STATE OF IDAHO
DEPARTMENT OF
ENVIRONMENTAL QUALITY

RE: Comments on Application to Permit No.: 29-14207

The Idaho Department of Environmental Quality (IDEQ) has reviewed documents relative to the Application for Permit for Intermountain Vipassana Association, Inc. We are offering the following comments.

Enclosure: Attachment A – Grace Nitrate Priority Area

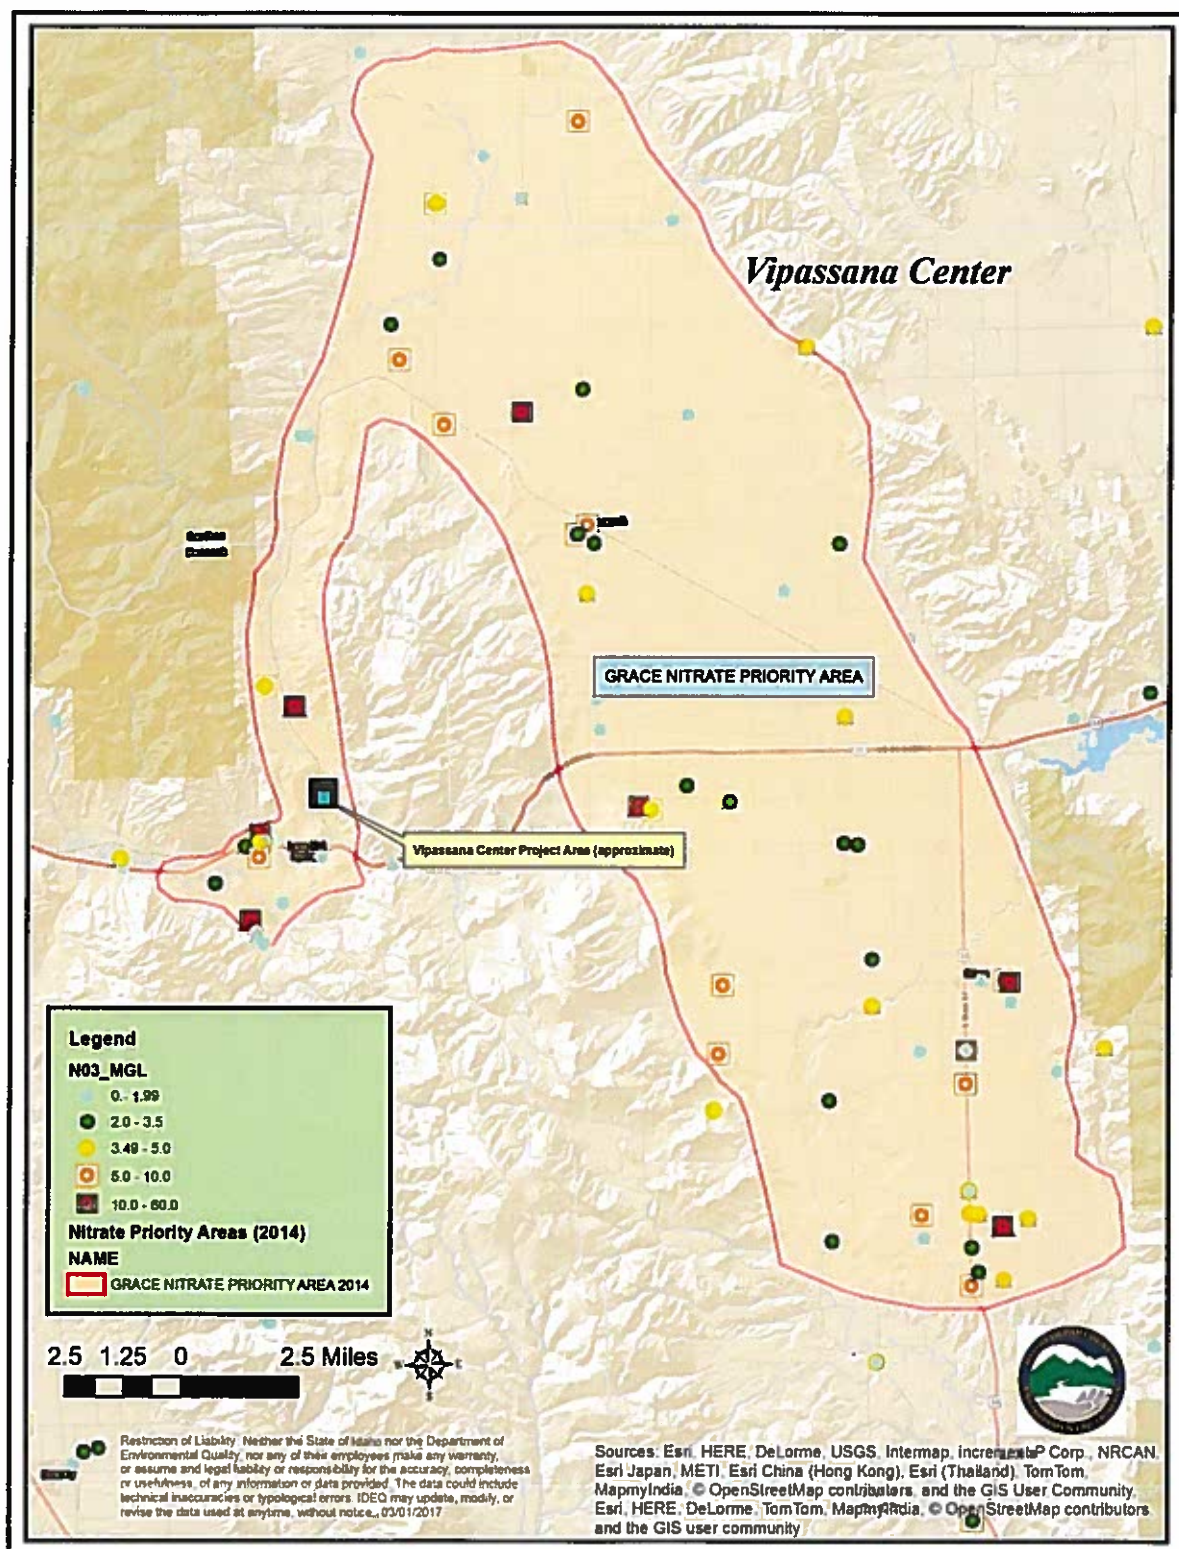
The proposed wells lie within the designated Grace Nitrate Priority Area (map attached). We recommend the applicants be advised that nitrate concentrations in potable water supplies might be elevated and that under some circumstances elevated nitrate concentrations can present a public health risk to vulnerable populations.
